Amendments to the Drawings

REMARKS

Figure 2

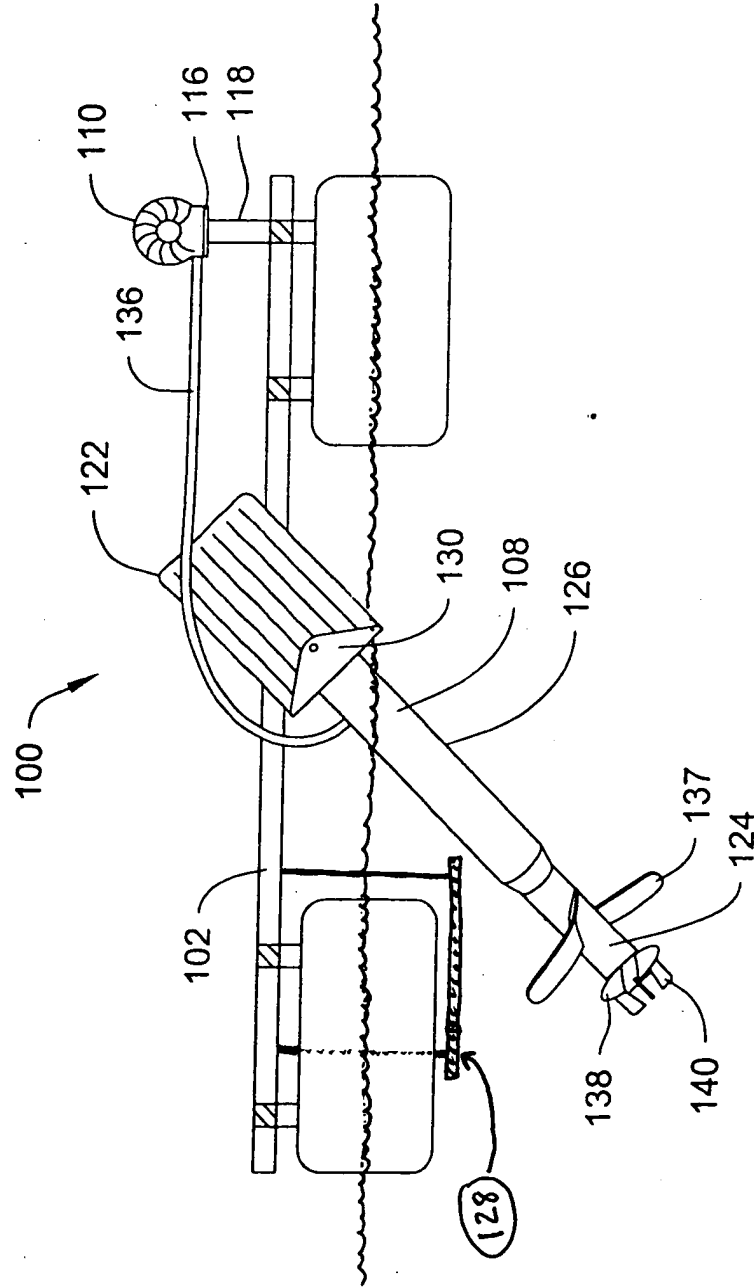
Attached is a marked-up drawing for Figure 2. Also attached is a Replacement Sheet for Figure 2.

Applicants have amended Figure 2 in order to more clearly show one of the embodiments of the Application. Specifically, the vortex plate is shown in Figure 2, along with showing the approximate water line in relation to the vortex plate. Support for this amendment to the drawings can be found, for example, at page 6, lines 9-17 of the Application as originally filed.
